COUNTY ADMINISTRATOR'S OFFICE
PIMA COUNTY GOVERNMENTAL CENTER
130 W. CONGRESS, FLOOR 10, TUCSON, AZ 85701-1317
(520) 724-8661 FAX (520) 724-8171

September 28, 2017

Re: **New information: Rosemont Copper Mine, Section 404 Clean Water Act**

Figure 9. A photograph of the slag and former smelter site from Google Earth (outlined in black). Needs and opportunities for remediation of this site, which may be contributing to degraded water quality, have not been investigated.

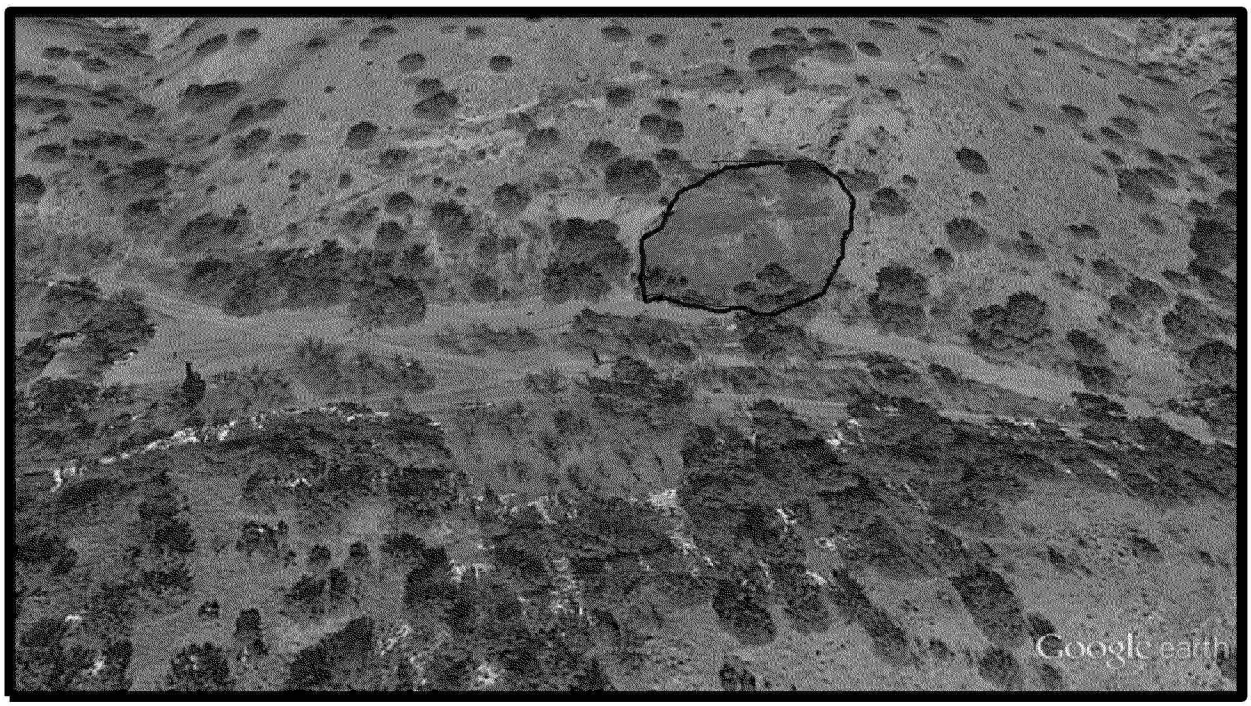
A smelter operated along Wasp Canyon just upstream of its confluence with Barrel Canyon from 1879 to 1905, and was subsequently removed. (Tetra Tech 2009 in Appendix 8, and Figure 9 below) The smelter site is exempt from APP regulations per §A.R.S. 49-250(B)(11). The APP applicant proposes to cover the slag pile and remains of the smelter site with new, "dry" tailings. We are unaware of any further site investigation that has been required by state or federal authorities.
